**STAFF REPORT  
WEST ALLIS PLAN COMMISSION  
Wednesday, February 26, 2020  
6:00 PM**

2. **Site, Landscaping and Architectural Plans for Aspen Dental, a proposed dental office, to be located at 10707 W. Cleveland Ave, submitted by Boulder Venture (Tax Key No. 519-9996-001)**

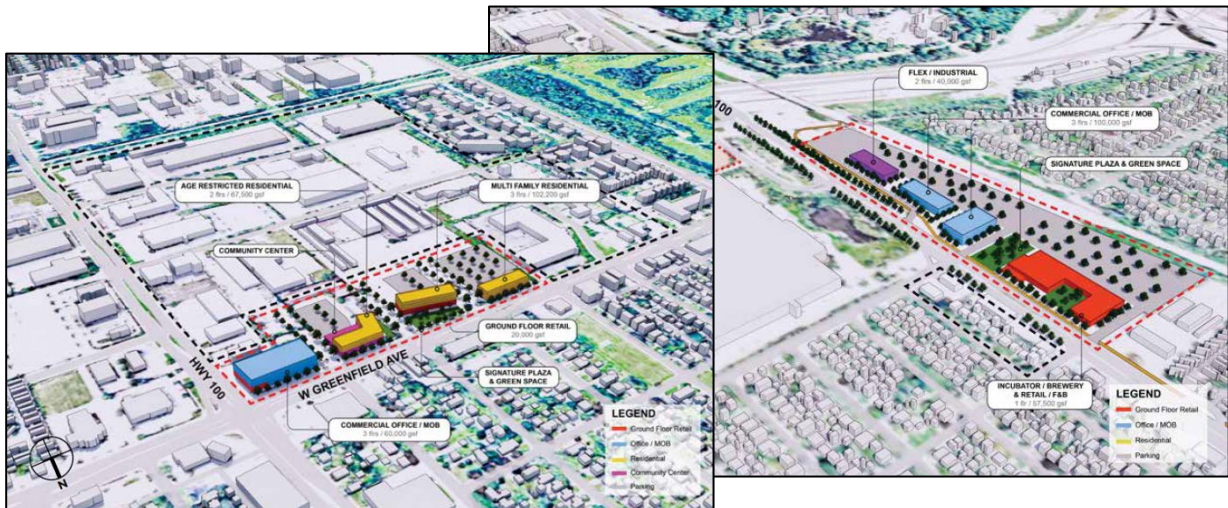
The applicant’s plan involves the construction of a new building on a site that is located at a very visible and well-traveled corner of the city, and which is proposed to be surrounded by parking stalls on all four sides. This type of development is outdated and

not in alignment with the City's Design Guidelines, which call for buildings to be situated toward the front of the lot, and scaled and detailed for the pedestrian, not only the automobile. A primary reason the applicant has cited for not locating the building at the preferred northwest corner of the lot is because an existing non-conforming pylon sign, which the applicant would like to see remain, is located there.

This site design runs counter to recommendations provided in the recently completed West Allis Highway 100 Corridor Plan (expected to be brought before Common Council with a recommendation to adopt next month). The Plan states that, “the long-term goal is that walkable, mixed-use destinations will be more common and that over time the Corridor will evolve into a place that is less auto and convenience oriented.” Looking closer at conceptual site designs, the Plan reveals future developments with building brought to the street, designed with people in mind, and with the idea that new development can be used as an opportunity to create a sense of place. None of the re-development recommendations or conceptual designs involve creating more parking lots on prominent city corners.

### *Lack of Proper Landscaping*

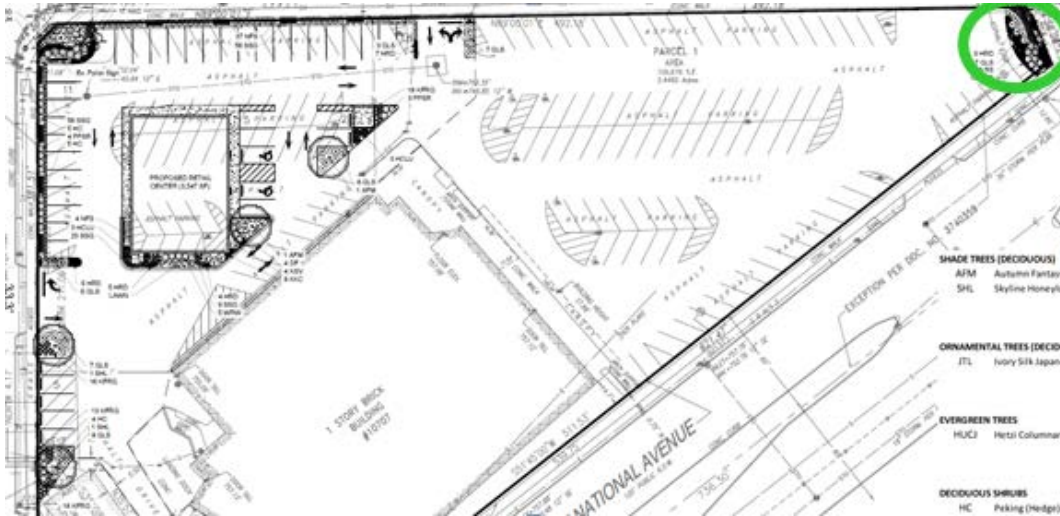
When Plan Commission conducts a site and landscape review, the review is for an entire parcel and all areas of the parcel should be brought up to meet the City's Code prior to approval of the revised plan. The applicant is proposing to make site and landscape improvements only in the area surrounding the new construction and a small portion of the northeast corner, but have not proposed any updates to the remaining areas of the site.

Looking at the overall site, the current proposal does not meet the landscaping requirements of the City's Design Guidelines. All development is required to devote a minimum of 10% of the area of the site plan to landscaping. Additionally, when looking specifically at areas dedicated to parking, at least 10% of the area used for parking should be dedicated to interior landscaping (plantings around the perimeter of the parking lot do not count towards the interior landscape requirements). Currently, there is no landscaping, either interior or around the perimeter, of the Office Max portion of the site, and minimal landscaping within the area of proposed improvement.

Further, provided with the option of taking a "phased" approach to making additional site and landscape improvements, the applicant asked that they not be required to do so until their lease with Office Max has expired, which could potentially be as long as 10 years from now. This is far outside of the timeframe any other development has been or should be allotted. Any approved plan should include appropriate site improvements to the entire site, within a timely manner. Additionally, the applicant has requested they not be required to provide a surety bond or other form of financial security for Phase II portion of site and landscape improvements, as required, should there be Phase II plans.

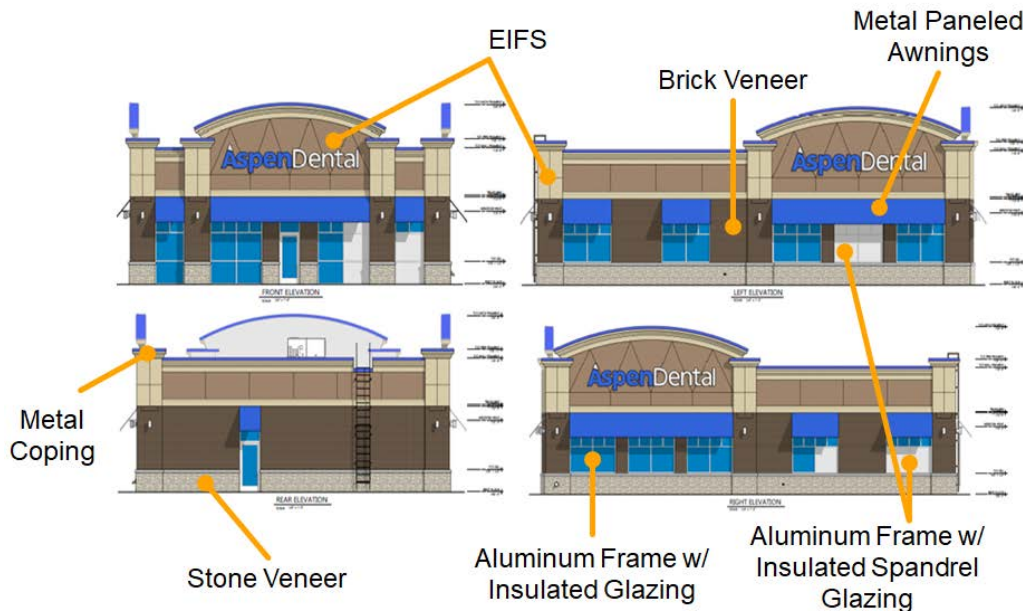
The current proposal includes an existing Office Max pylon sign remaining in place, despite the sign being non-compliant with current Code standards. Prior to plan approval by Plan Commission, non-conforming elements should be removed from plans and a specific date of when the non-compliant element will be removed should be identified (typically within 2 years). Similar to the Office Max parking lot area/landscaping issue, the applicant is requesting the non-compliant sign be permitted to remain for the entirety of the Office Max lease, which may be as long as 10 years from now. Again, this is far

outside the timeframe any other development has been or should be allotted to remove non-conforming site elements on a site plan they would like to see approved by Plan Commission.

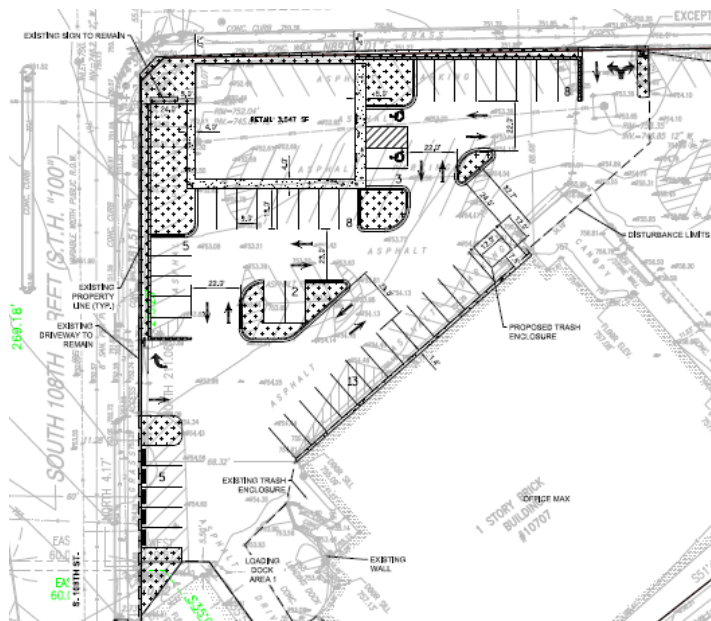
While this version is also not perfect from staff’s perspective – the site was designed around maintaining a non-conforming sign, there is an excessive amount of parking, and only a minimally sized landscape buffer around the parking’s perimeter – staff felt we were coming to the table with a plan that both parties could potentially agree upon, as it does increase overall landscaping and brings the building up to the front of the site.

*In both proposals, the rear of the building will be facing Hwy 100 and staff agrees that the rear elevation must be improved substantially prior to plan approval.*

*This is also true for both proposals.*

*Staff’s proposal actually provides more parking directly against the building and reduces the distance that a majority of patients would be required to walk through a parking lot.*

*Staff agrees that the non-conforming pylon sign is an issue and that it should be required to come down within 2 years as a condition of plan approval, as required by City Code. This would also eliminate the conflict with Aspen Dental signage. The applicant is choosing to develop on a site with a non-conforming sign and thus, must choose what they value more – the new development or the non-conforming sign – they are not permitted by right to have both.*

4. Plan Commission approves staff's version of the site plan, with conditions of approval. Conditions of approval may include:
    - a. Revised Site, Landscaping, and Architectural Plans being submitted to the Department of Development to show the following:

- i. A detailed Phase II plan showing site and landscape improvements being completed on the entire site within 2 years of plan approval (a

- specific date to be included on the plan), which Development staff approves, and which identifies the proposed species and total number of plantings to be approved by the City Forester;

- ii. A note stating that the non-conforming pylon sign will be removed within two years of plan approval.
  - iii. integrate pedestrian walkways between various structures on overall site (both Phase I and Phase II plans);
